Revised & Amended
Paseo de la Riviera Analysis
for
Riviera Neighborhood Association

Analysis and report by:
Mark Alvarez
Integrated Urban Planning, LLC
786-208-6655

This report is at the request of and on behalf of the Board of the Riviera Neighborhood Association, Inc. The report summarizes an independent planning review of the proposed mixed use redevelopment project called *Paseo de la Riviera* at 1350 South Dixie Highway (US-1) in the City of Coral Gables, Florida. The review is focused on the planning requests that are before the City Commission.

*North Façade Elevation not available
Residential Building: 147'-6" total height, 122'-6" to roof, 312' building width
Stepback from Madrugá Avenue is 79'*

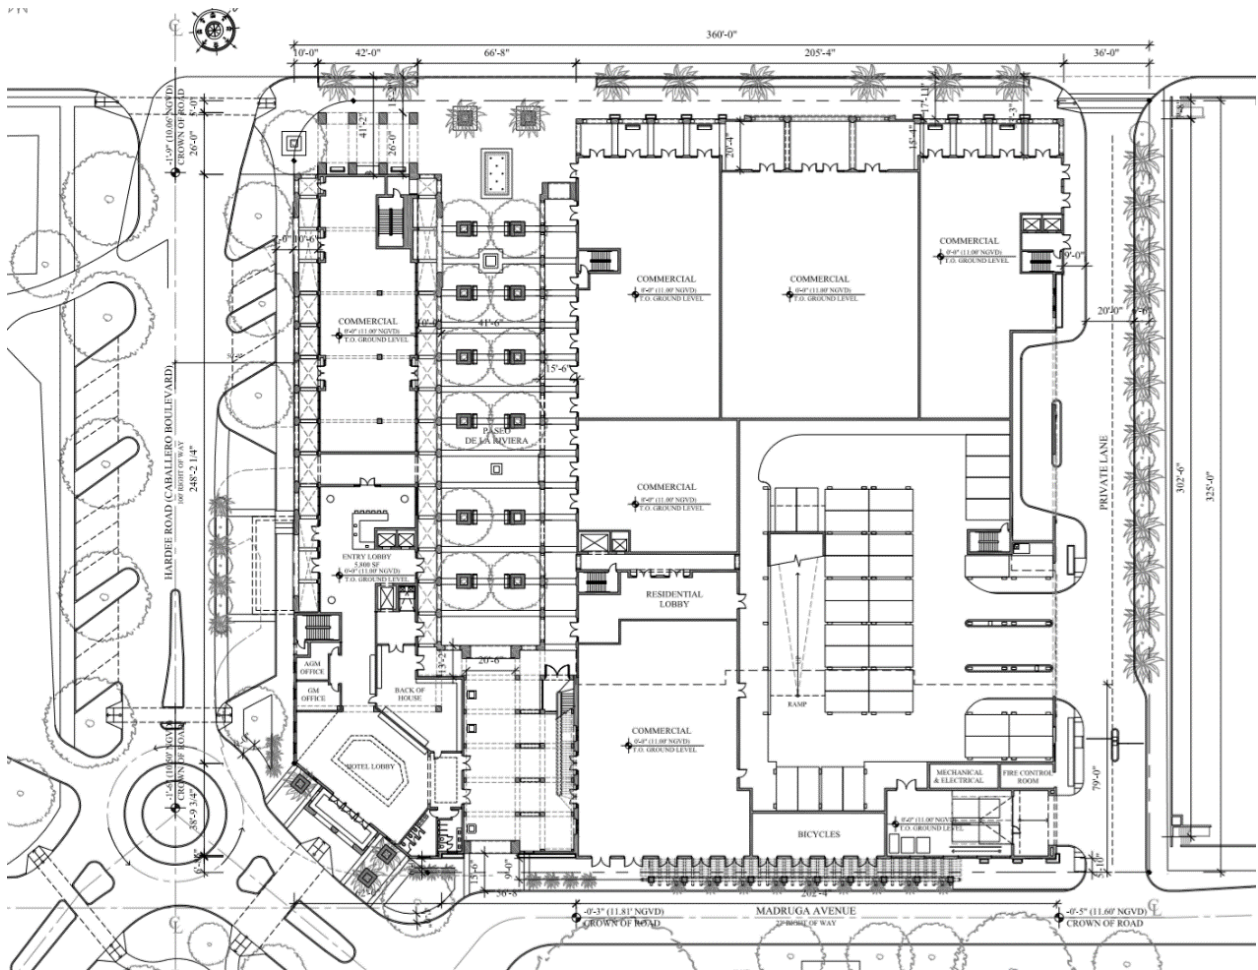
excessive. This is particularly the case for the Madruga step back in which 79 ft. is requested. The code requires 100 ft., and implementation of George Merrick's Vision to provide desired enclosure for US-1 and compatibility and compatibility with the residential neighborhood, it would require 200 ft.

4. Approve PAD without setback variances, add setback conditions, and regulate FAR
 - 45' height at Madruga with 100' stepback to tower (3-502 C.9)
 - 10' setback at US-1 (5' provided: total with ROW approx. 20': pedestrian path, with utility encroachments)

Figure 15 Paseo de la Riviera Roof Plan showing 1930 4th Height District Line

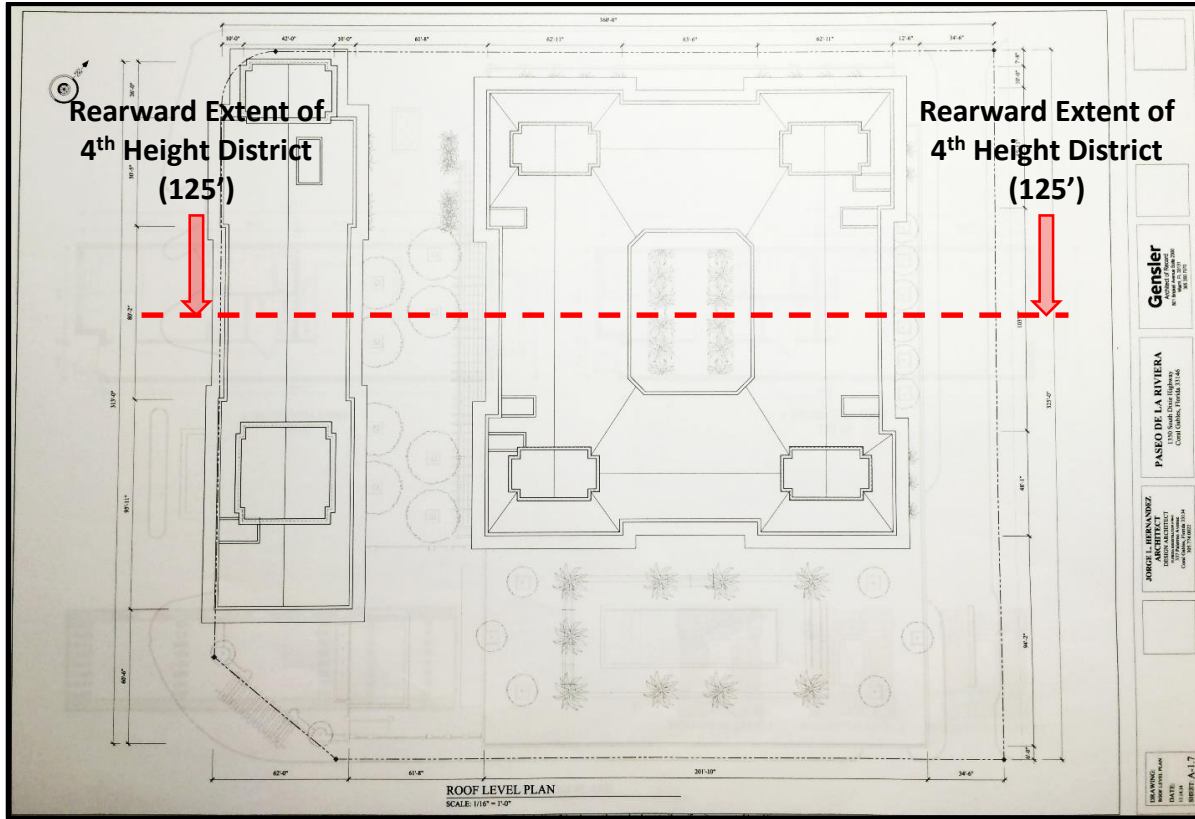
The answer is that the 1930 code did protect this area. The interpretation made by the Applicant is only partly correct. Indeed, the front of the structure, administered by George Merrick's vision would be permitted at 150 feet; however, this is not true for the whole block. Note that the original plat for this block differs from the current configuration for Tract A (see Figures 13 and 14). The original platting had an alley that bifurcated the depth of the block in half, and the location of Madruga Avenue was on the same alignment as where it is today between Mariposa Court and Maynada Street, and south of the Mahi Waterway. The re-plat of Tract A moved Madruga Avenue and halved its ROW section to allow for a deeper block. The centerline to centerline distance between US-1 (100' ROW) and Madruga Avenue (60' ROW) at the original location) is 300 feet. Subtracting ½ of each right-of-way, then the original block depth is 270 feet. Only half of this depth minus half the width of a center-block alley (minimum 20') was in the 4th Height District. The Fourth Height District that is depicted in the 1930 Height District Map is 125 feet deep, not the 325-foot depth that Tract A is today.

Therefore, George Merrick's vision, to the extent that its implementation is of superior importance to today's regulations would only permit a 150-foot building only within the front 125 feet of the block depth. Past that line to Madruga Avenue, the 1st Height District applies, and the structure would be limited to 3 stories and 40 feet to the roof (ceiling line). The existing Tract A block depth (325 ft.) exceeds the original depth of the 4th Height District by 200 feet. The Paseo de la Riviera high portions of the towers exceed this limit by 135 feet for the hotel tower (260 ft. back from US-1 property line), and 100 feet for the residential tower (225 ft. back from US-1 property line) (See Figures 15 and 16). Further, the parking pedestal height within the 1st Height District exceeds the 40' height to the roof line by 18'-6". The hotel pool deck pedestal does not exceed this limit.
